Request for Well and Septic Service

1/23/13
10805 MILL STATION RD.

PRE PERC SITE EVALUATION

Pre-Perc Field Notes

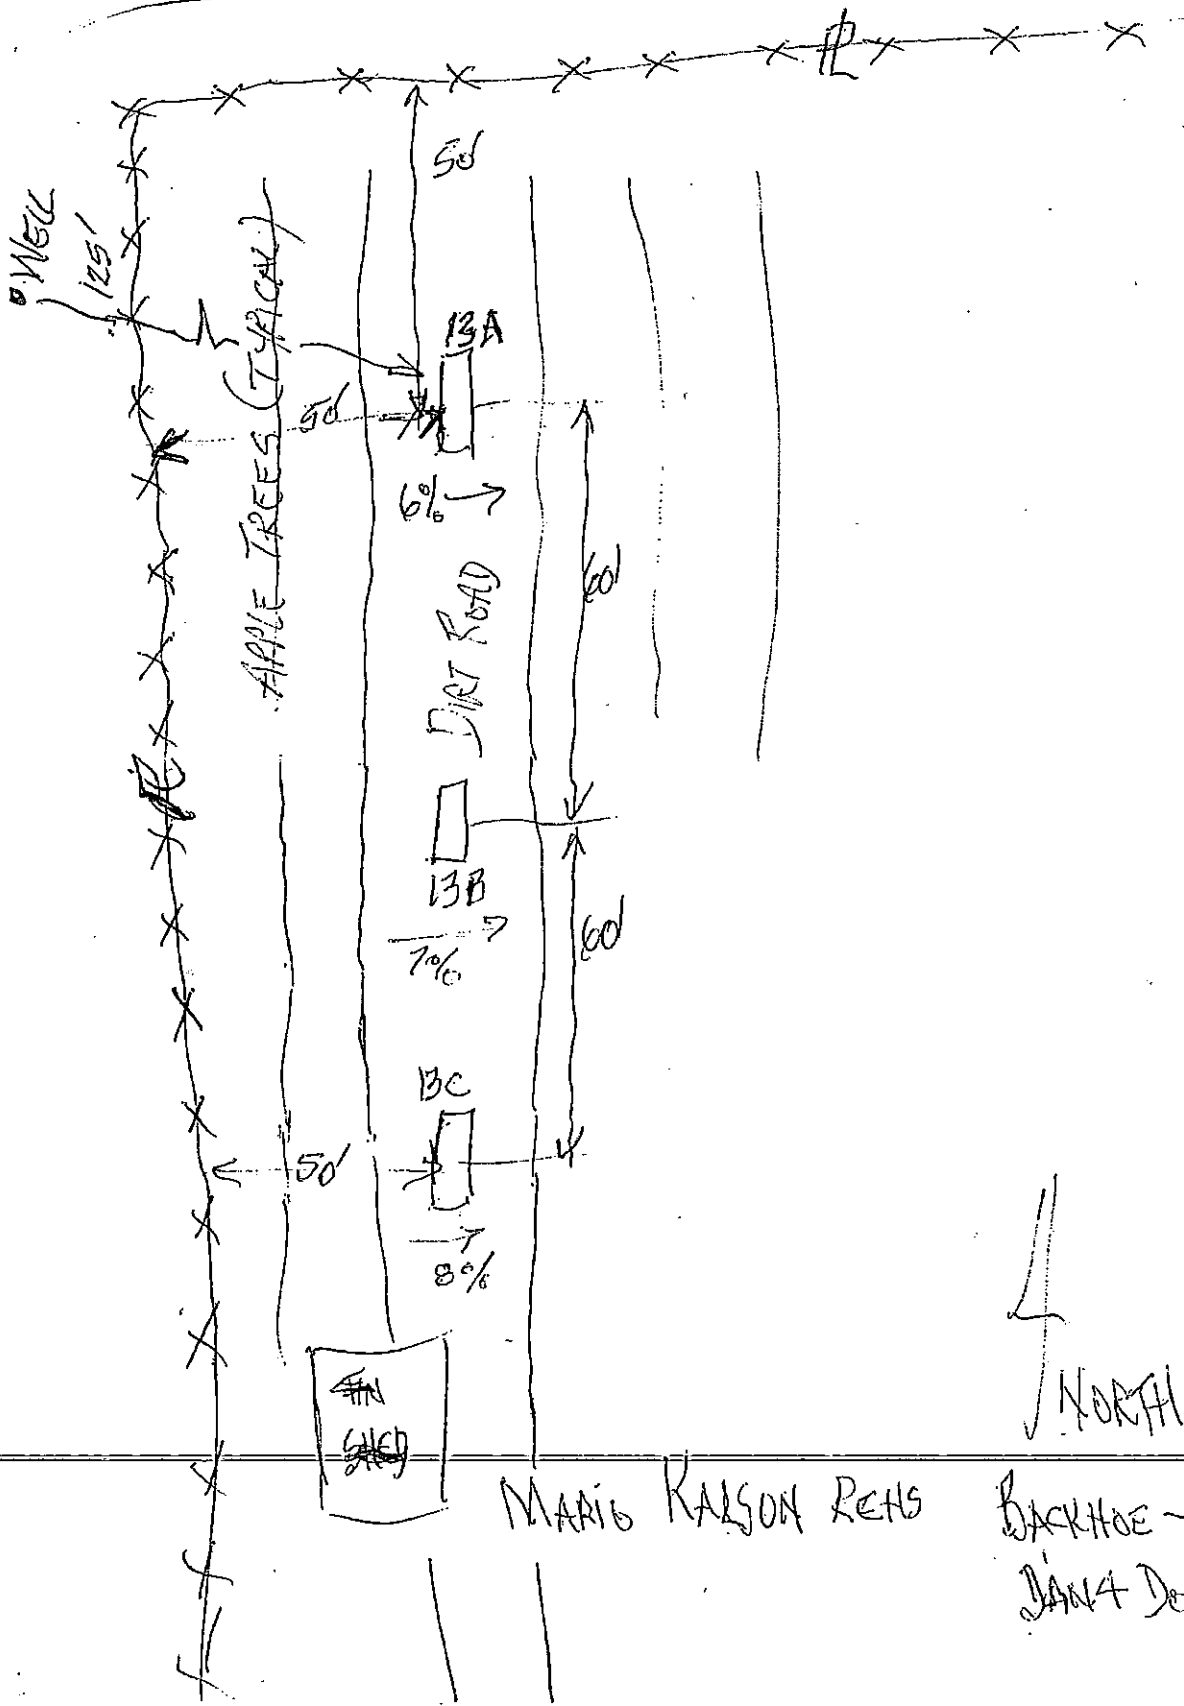
Address: 10805 Mill Station Rd		Pre-Perc date: 01/29/13		Time: 1:45pm	
AP# 001-030-025		Site Review by: MKALSON			
Test conducted by: D. Wright of D4		Subdivision: Yes ☐ No ☐		Initial ☐ Supp. ☐	
Test verified by:		Water availability zone: Zone 2			
Special standards area:		SCS soil type: GdD			
Topography: Ridge ☐ Slope ☒ Saddle ☐ Basin ☐		Convex ☐ Planar ☐ Concave ☐			
Setbacks: Cutbank/grade break ☐ Wells ☐ Springs ☐ Streams ☐ Ponds ☐ Drainage ☐					
Areas of concern: Trees ☐ Drainage ☒ Geology report ☐ Rock outcrops ☐ % Rock: GW ☐					
Hydrometer test: Yes ☐ No ☒ Depth(s):		Bulk density: Yes ☐ No ☒ Depth:			
Wet-weather perc required: Yes ☐ No ☒		Wet-weather groundwater required: Yes ☐ No ☒			
Subsoil perc depth(s):		Pump System: Yes ☐ No ☐ Perc depth(s):			
Type of system:		Eng. Design ☐ Topographic map req. ☐ Geology report req. ☐			
Comments: Sullivan Road side ditch ~ 50' North of Profile A; Neighboring Well ~ 125' from Profile A

Show all wells within 150' and maintain setbacks to roadside drainage.
